**Technischer Service Hinweis
Technical-Service-Announcement
Nr. / No. 03-2014**

O-Ring NBR

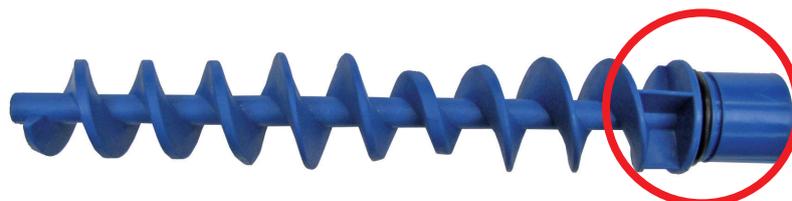
With immediate action an improved O-Ring to seal the shaft of the Powder-Dosage System will be used.

The new O-Ring is made out of NBR-Material which has less wear & tear against abrasion. Order-No. is 346603

O-Ring ALT/ OLD
21x2 VITON
Art-Nr./ Part No.
346602

O-Ring NEU/ NEW
21x2 NBR
Art-Nr./ Part No.
346603

We recommend to change the O-Ring during the next Service call-out.
